PCN 19\_0094

## ADGM1004 Data Sheet Changes

### Rev.C to Rev.D

This document highlights the changes from the Rev. C to the Rev. D data sheet for the ADGM1004 SP4T MEMS switch with integrated driver.

Figure 4 Typical Operating Circuit in Parallel Mode for ADGM1004 Rev D

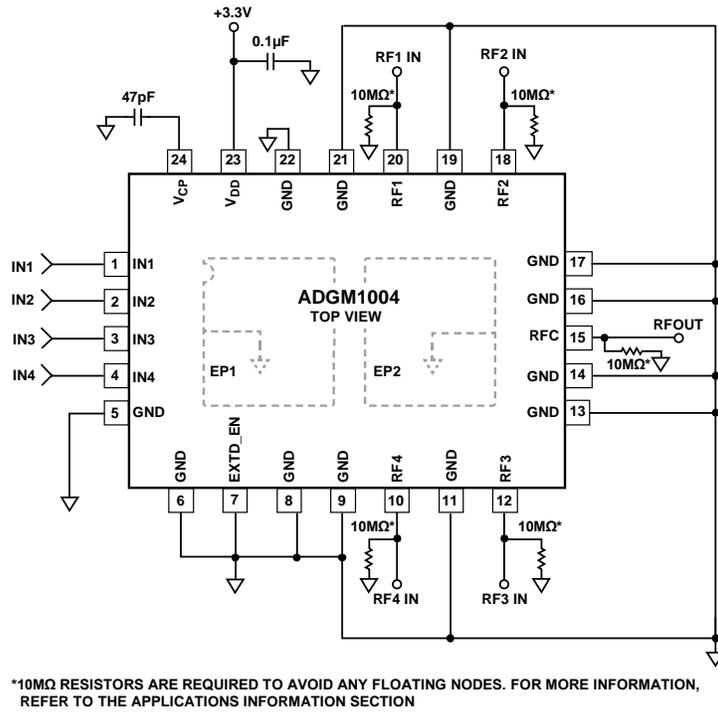
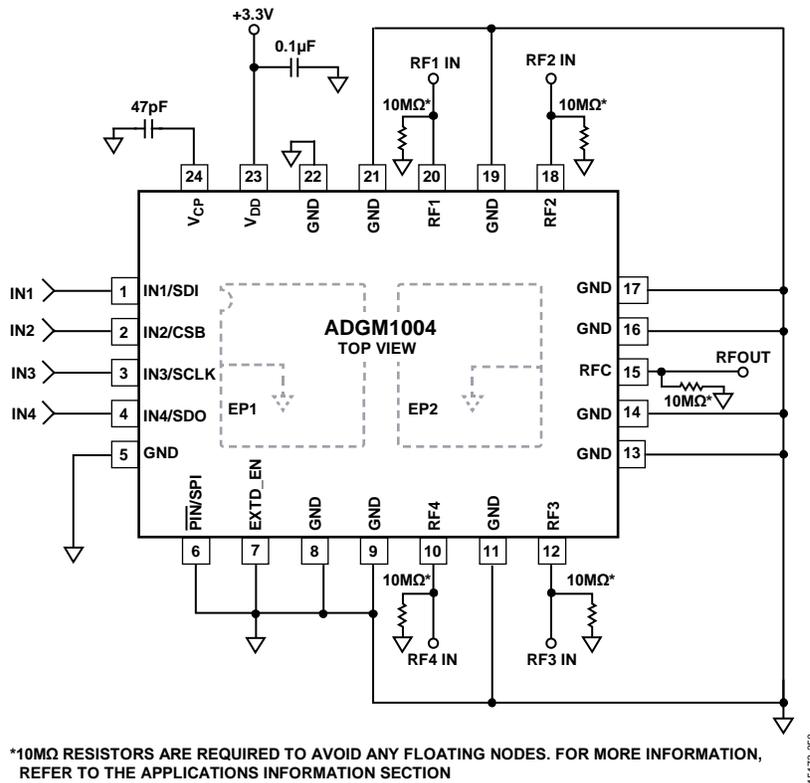
Figure 3 and Figure 4 outlines the typical operating circuit comparison of the Rev. C to Rev. D material. There are no changes to typical operating circuit in parallel mode for both Rev C and Rev D material.

Figure 6 50 Ω system representation where the ADGM1004 is connected with the load

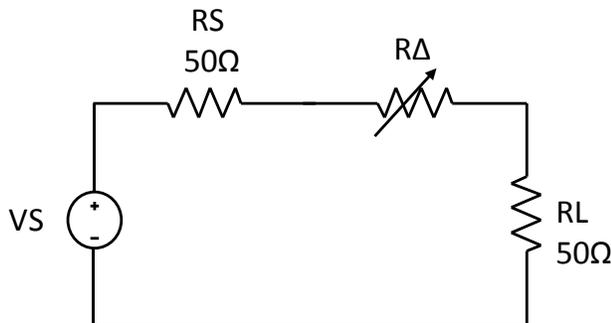
ADGM1004 Ron varies over time and over actuations. In a 50 Ω system, the on-resistance drift over switch actuations can introduce system inaccuracy. Figure 5 shows ADGM1004 connected with the load in a 50 Ω system. The system error caused by ADGM1004 RON drift can be calculated by equation(1)
